Re: Lomas/Yale Intersection Improvement Plans
Engineer's Stamp dated 8-22-07

Based upon the information provided in your letter dated 8-22-07, the above referenced calculations have generated the following questions that should be addressed before I can sign the plans

Re: Lomas / Yale Signal Modifications, COA 724685

LOMAS BOULEVARD SIGNAL MODIFICATIONS
DRAINAGE PLAN
YALE BOULEVARD / LOMAS BOULEVARD

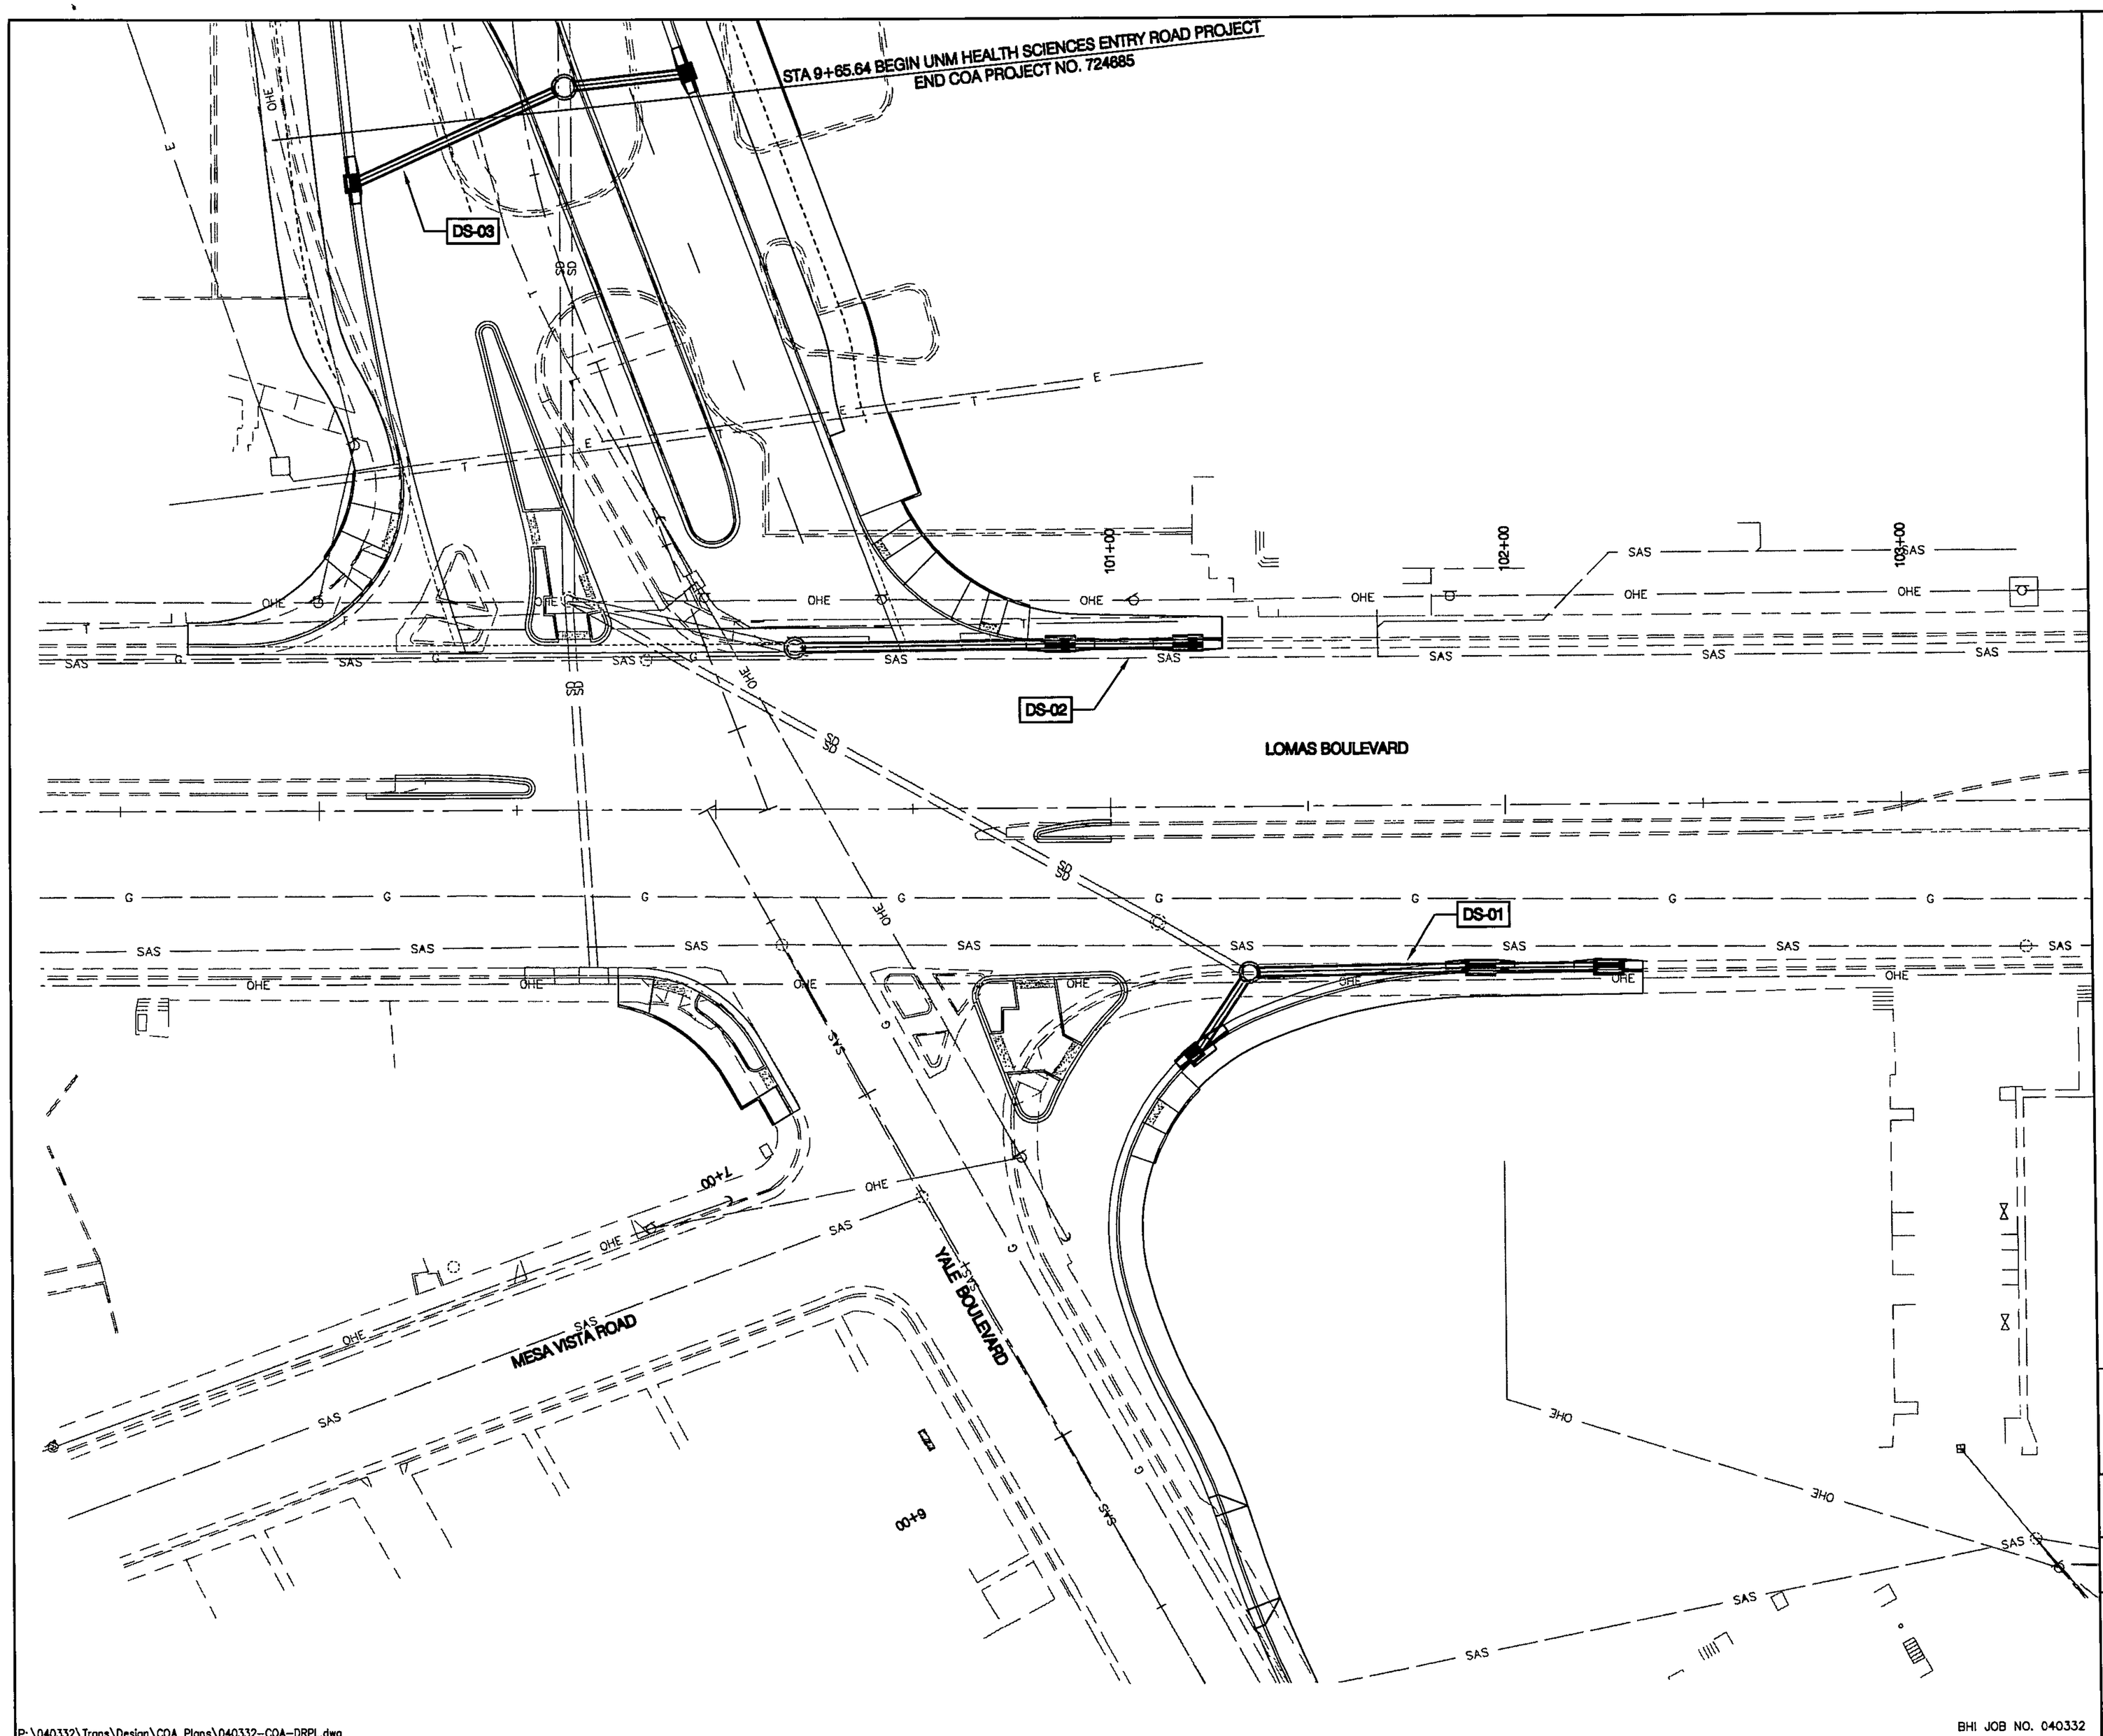
- None of the City's nomographs come close to showing that 27.93 cfs can enter a double 'C' inlet. I am aware that it does not take the curb openings into account but your calculations did not include any clogging factor.
- My site visit indicates that the curbs in the area are less than the 8" depth you have shown in your calculations. How will this affect your calculations?
- This location is the last chance to get upstream runoff to drain to the river by gravity. Any bypass is pumped, either from the Claremont pump system or the Broadway system and improving inlet capacity may pressurize the existing pipe network better and dry up Martineztown a little. I am still of the very strong opinion that I need the same grate area and curb opening that I have now.

In response to your comments from the previous submittal, attached are the calculations and stamped construction drawings for the existing and proposed inlets in Lomas at the entrance to UNMH. The existing inlets have a capacity of 112.5 cfs. However, the storm drain pipes that carry the runoff to the box culverts limit the amount of flow that will actually be captured from the street to no more than 80 cfs. That flow rate is based on an averaged slope from the lowest inlet invert to the outfall into the box culverts. We were unable to open the manhole where the inlet pipe ties to the 42" to get its actual invert. Most likely the 42" pipe is at a slightly flatter slope and the actual capacity is more in line with the 62 cfs given in the previous report. Either way the pipe controls the flow that gets from the street to the boxes.

The proposed inlets have a capacity of 96.6 cfs. This is still greater than the pipe's capacity and does not change the existing condition.

The calculations in the spreadsheet are taken directly from the USDOT's Urban Drainage Design Manual, HEC No.22. If you have any questions please feel free to call.
